June 8, 2026

2025-CRW-1019

**Re: Addendum No. One (1)**  
Snow Removal Equipment (SRE) Building  
3-54-0003-087-2025 (Design)  
3-54-0003-XXX-2026 (Construction)  
West Virginia International Yeager Airport (CRW)

A303

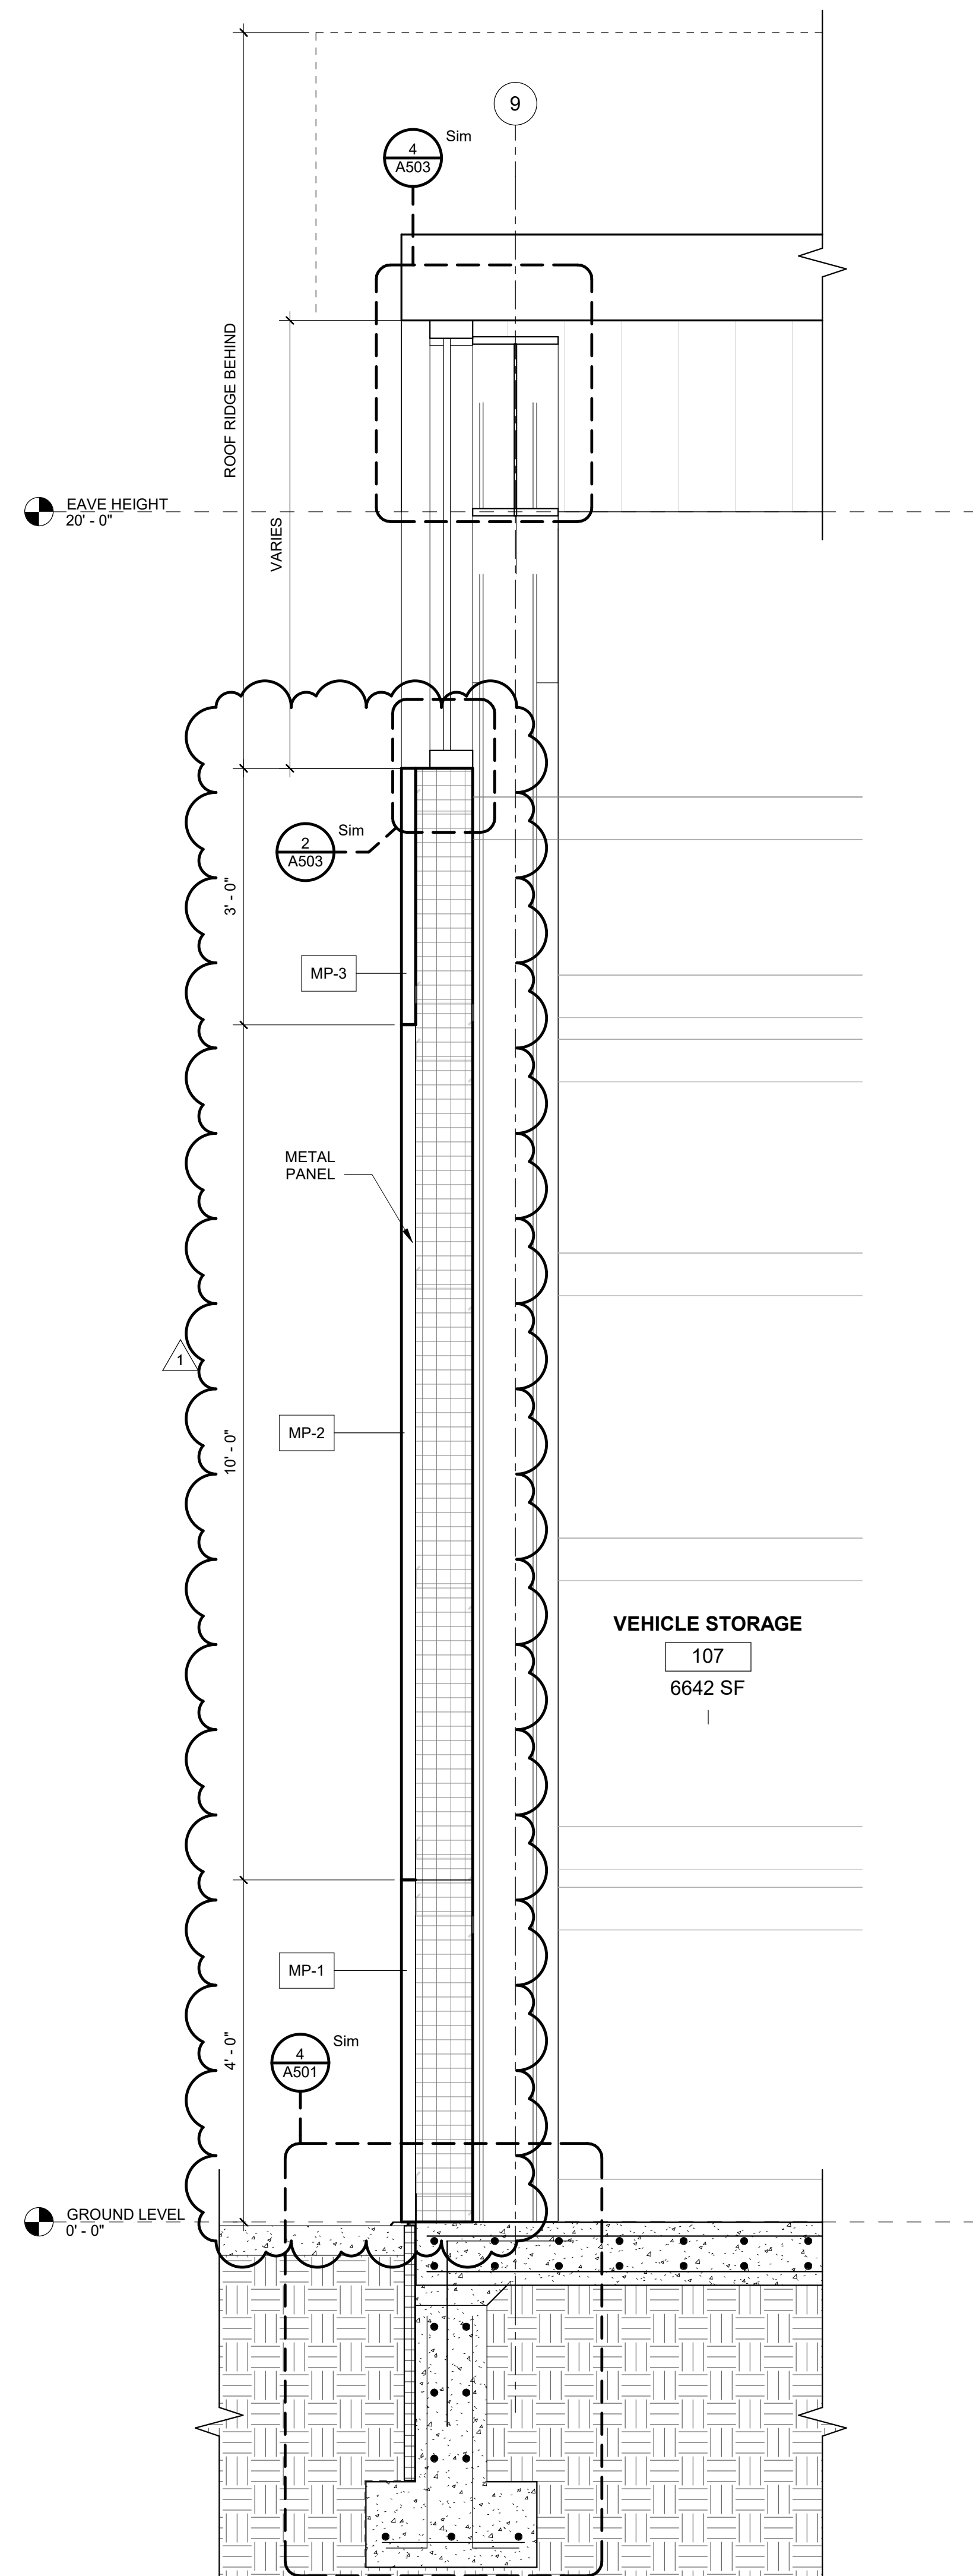
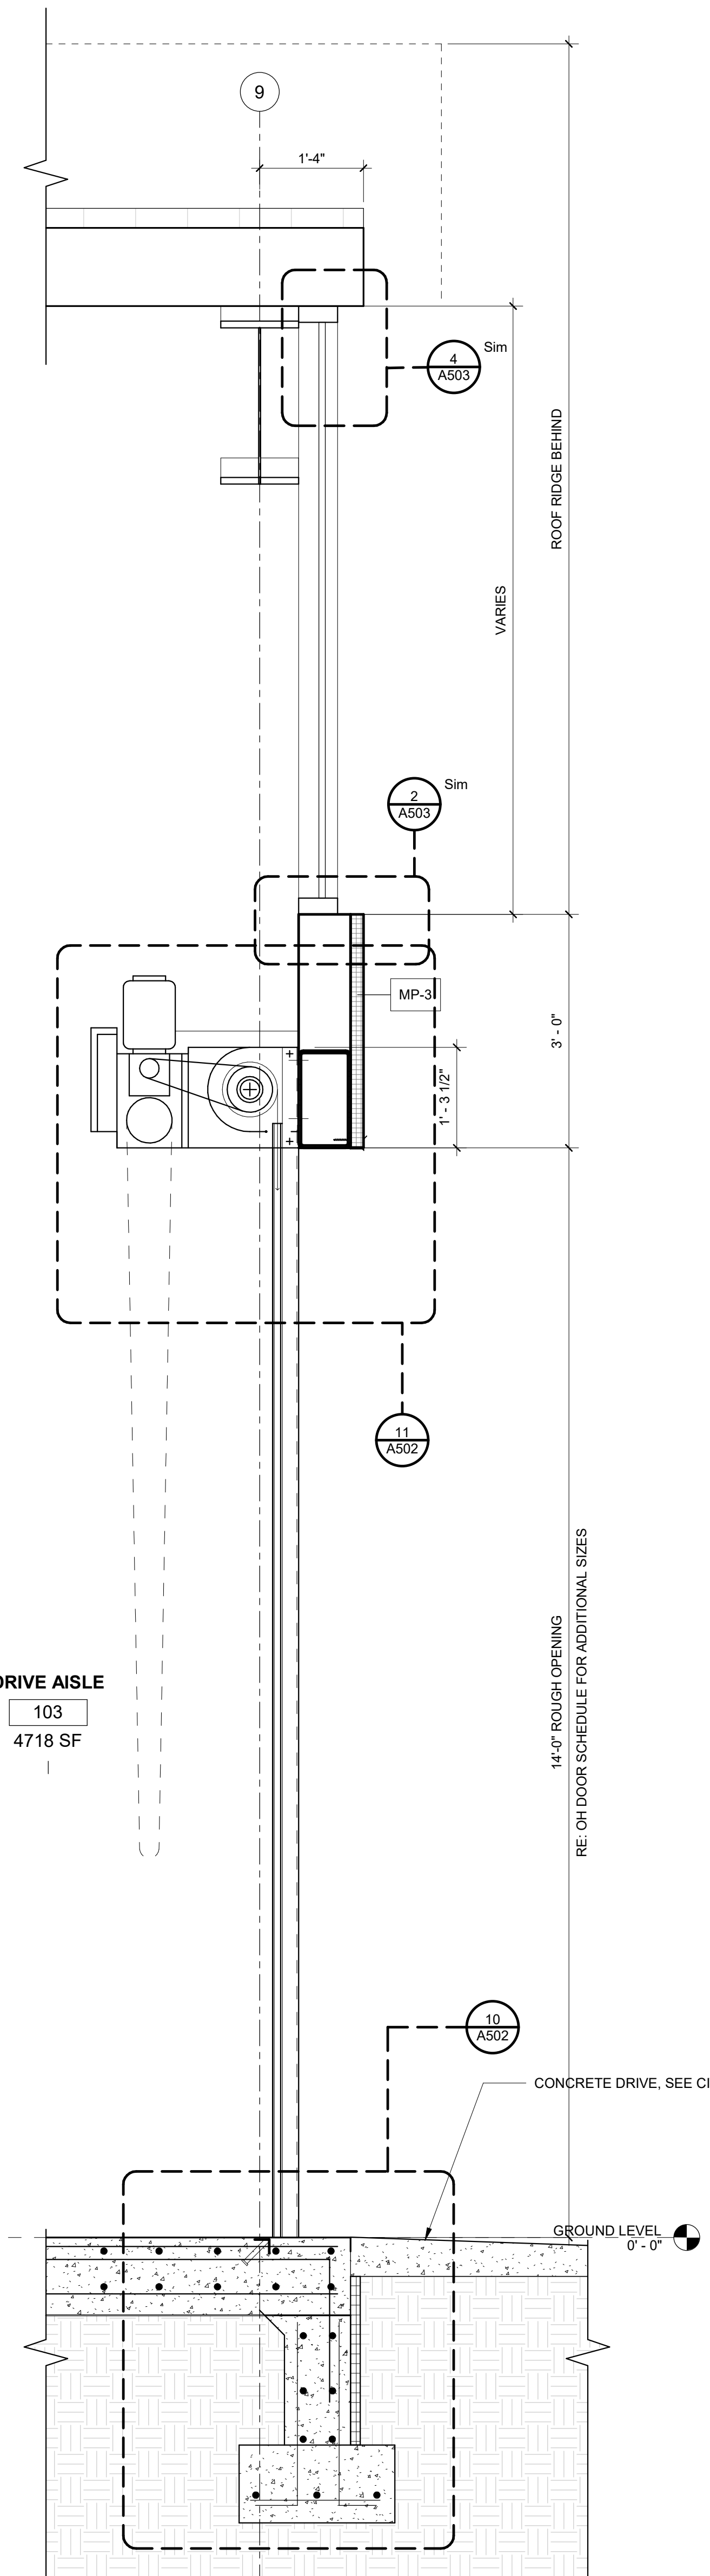
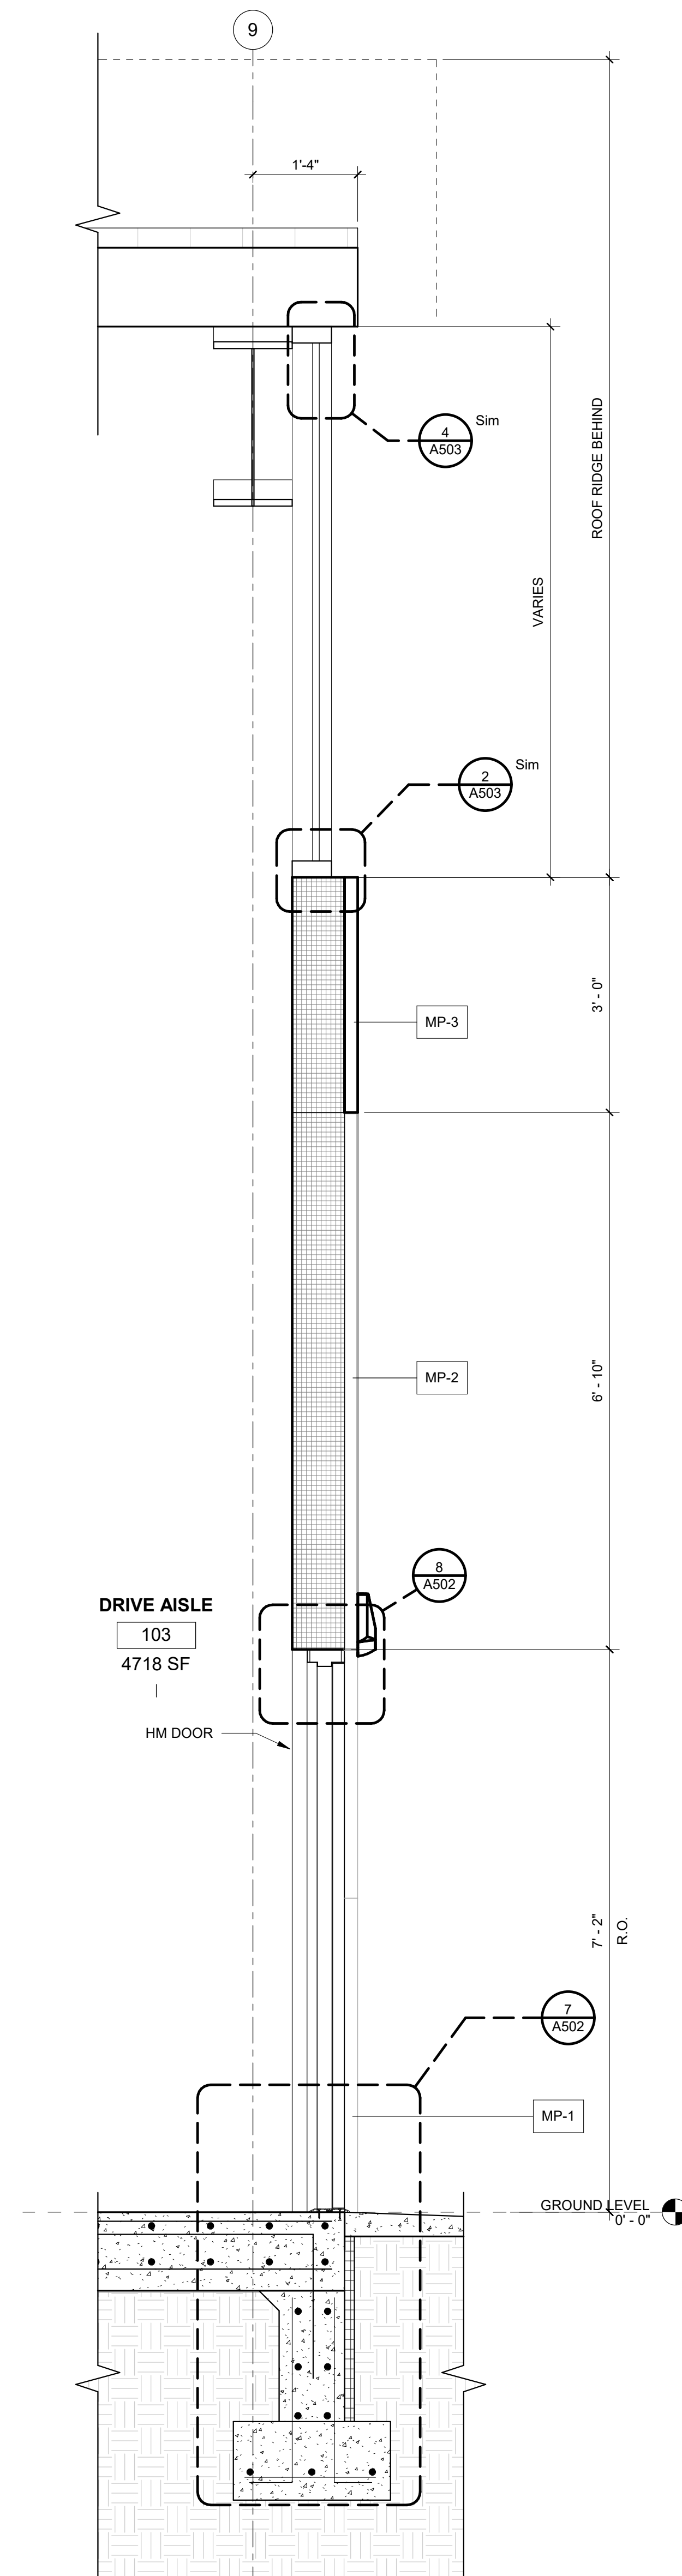
- 1.16.1 **REVISE** Details to show base bid with Metal Panel & Interior Insulation
- 1.17 **REPLACE** Drawing No. A501 with new A501 attached to this Addendum No. One (1).

- Q39.** A103 Does not show a ceiling  
A301 – Section 2 shows interior ceiling height at 15’  
Please clarify.  
**A39. The Ceiling elevation reference is for the ceiling in Room - 102 ‘Parts’. Refer to Wall Section 3/A302.**
